RE: ABQ Studios Expansion WO #3 (CPN: 393587)
Drainage Management Plan
Engineer's Stamp Date: 3/8/2023
Hydrology File: R16DA2006

Re: ABQ Studios Expansion WO #3
Drainage Report and Drainage Management Plan Comments
Engineer's Stamp Date: 1/27/2023
Hydrology File: R16DA2006

**ABQ STUDIOS EXPANSION
WORK ORDER PACKAGE 3**

DRAINAGE MANAGEMENT PLAN

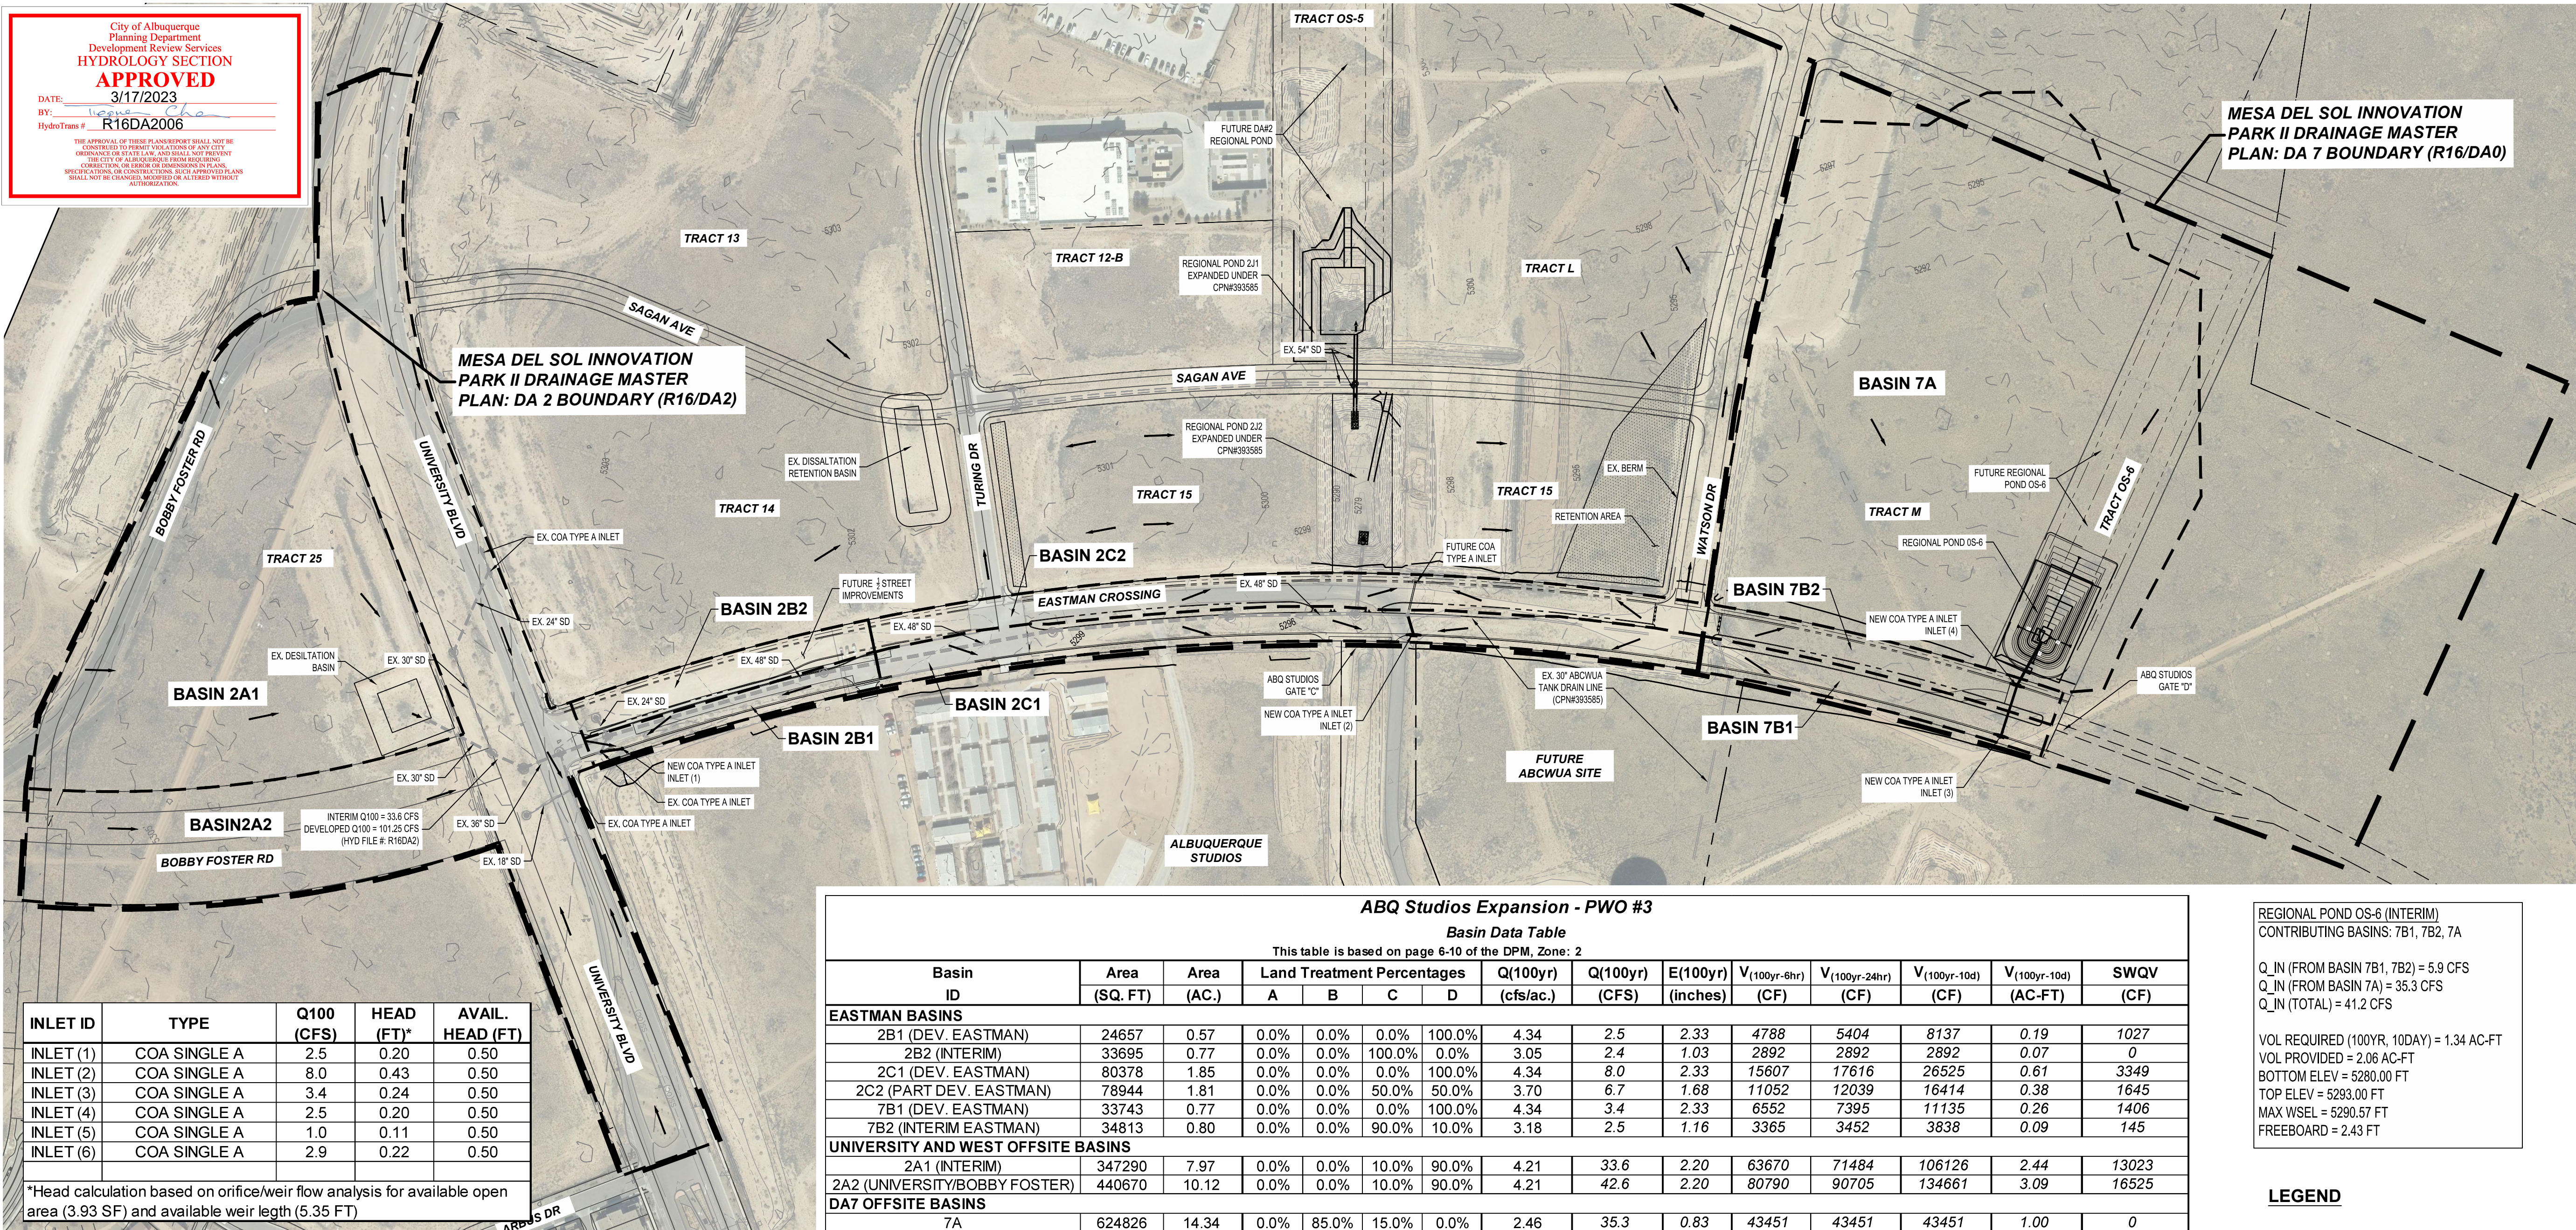
1. **Please add contour elevation labels.**
 - a. Elevation labels added throughout the plan to show elevation references for major contours.
2. **Provide the Benchmark information (location, description and elevation) for the survey contour information provided.**

- a. Provided. These also correspond to the survey control sheet that was prepared with the CPN #393587 plan set.
3. **Was the drainage report included? I only found the drainage management plan from the file downloading weblink.**

4. **I couldn't find "Basin 4A1" in the "Existing Conditions", do you mean "basin 2A1"**
 - a. Yes, the updated narrative has been edited to reflect the reference to "Basin 2A1" that aligns with the tables and plan view.

5. **Provide the regional retention pond number located to the south in the "Existing Conditions". Provide drainage calculations showing that this pond have enough volume capacity to accommodate discharge from the Stryker Road.**

6. It'd be easier to read if the Eastman Crossing and Stryker Road plans being placed on to two separate sheets.

- a. A separate drainage report was not included, as BHI felt the drainage conditions and considerations were accurately and fully represented with the provided Drainage Management Plan.

- a. Pond MDS-OS7, CPN #775684, Hydrology File R16D097A. Calculations were not provided because no additional flows (compared to existing) are being discharged to the pond as a result of this Public Work Order improvements. The proposed changes to the northern curb line of Stryker Road actually decreases the amount of discharge reaching MDS-OS7. See CPN #775684, Hydrology File R16D097A for regional pond analysis.

- a. Understood, however as the improvements to Eastman, University, and Styker are all part of the same COA Public Work Order, we felt that it was most appropriate to have a single Drainage Management Plan that corresponds to the single Public Work Order plan set.
